UNITED STATES PATENT AND TRADEMARK OFFICE

APPLICATION NO.	FILING DATE	FIRST NAMED INVENTOR	ATTORNEY DOCKET NO.	CONFIRMATION NO.
10/622,150	07/16/2003	Matthew Louis Courcy	NSC-P05579	1923
7590	04/13/2005		EXAMINER	
WAGNER, MURABITO & HAO LLP			WILLIAMS, HOWARD L	
Third Floor			ART UNIT	PAPER NUMBER
Two North Market Street				2819
San Jose, CA 95113

Office Action Summary	Application No.	Applicant(s)
	10/622,150	COURCY, MATTHEW LOUIS
	Examiner	Art Unit
	Howard L. Williams	2819

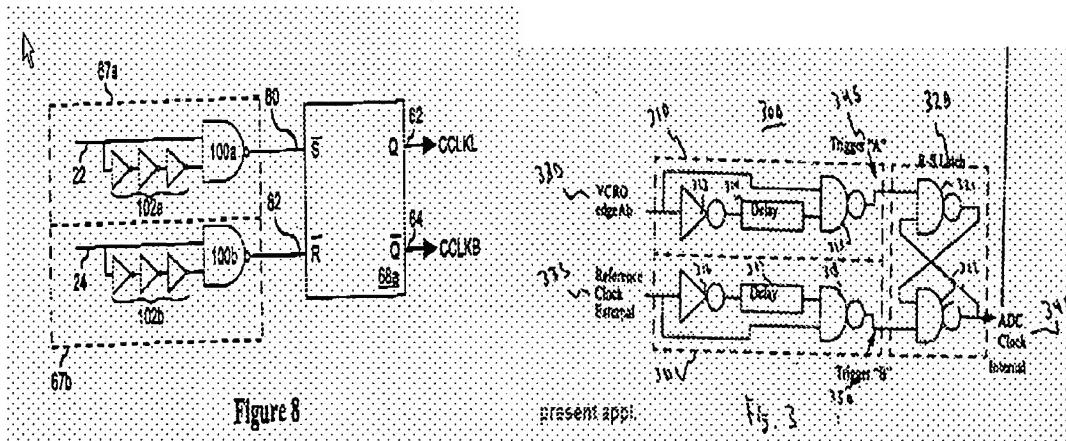
Claims 1-3, 5, 13-15 and 17 are rejected under 35 U.S.C. 102(b) as anticipated by U.S. P.A.P. 20020017936 A1 to Stark et al. Stark in figure 8 discloses: edge detectors (67a & 67b) and latch/S-R flip flop (66a).

Stark's figure 8 (on the left above) has the same configuration as figure 3 of the present application since the inverters 102a and 102b provide delay circuits. The inputs (22, 24) to the Stark edge detectors are complementary clock signals and 180 degrees out of phase. In the terms of signal period and duty cycle would be one-half clock period delayed phase.

FIG. 2

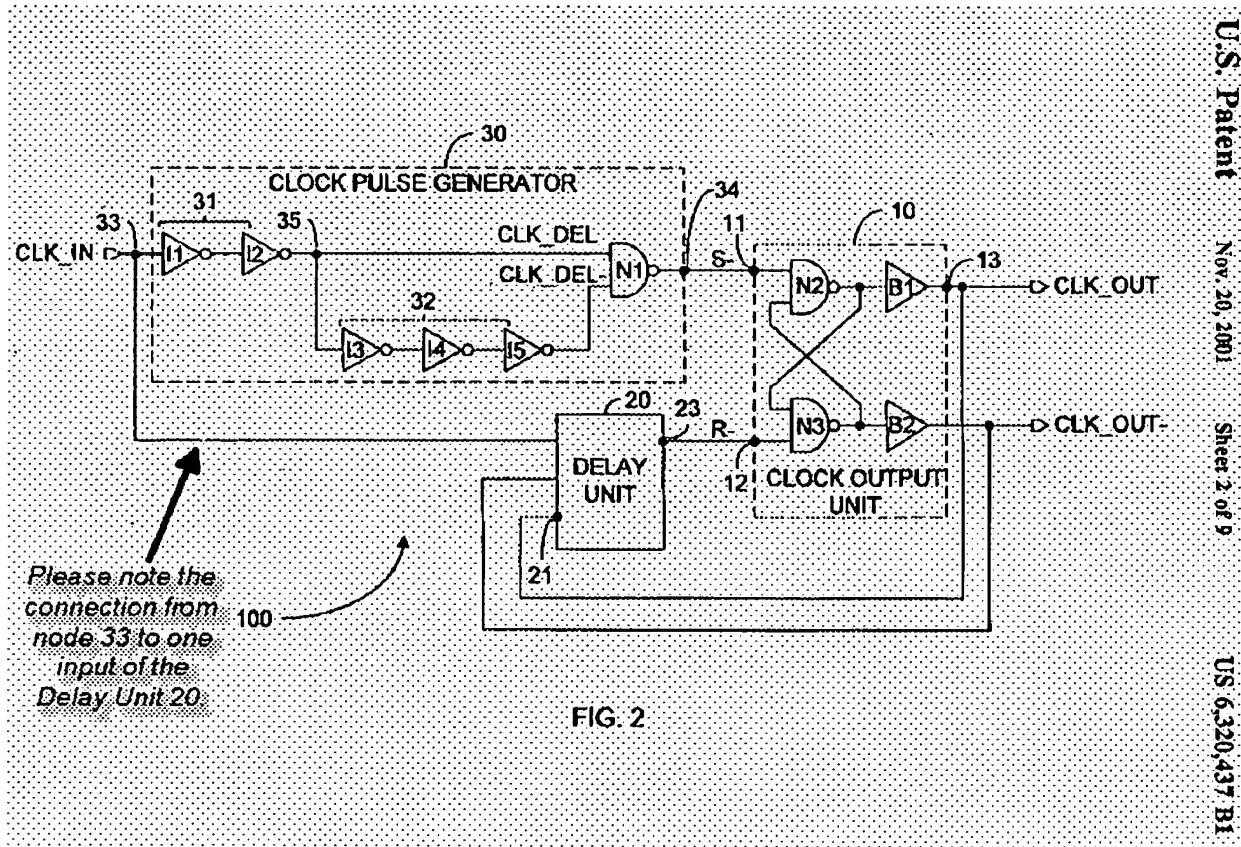
The remarks urge that Ma is not suitable to support the rejection of the claims because the delay unit (20; fig. 1 & 2) receives a feedback signal from the output of the

latch circuit. While the feedback is the only illustrated signal in figure 1 supplied to the delay unit such is not the case with figure 2 (inserted below)
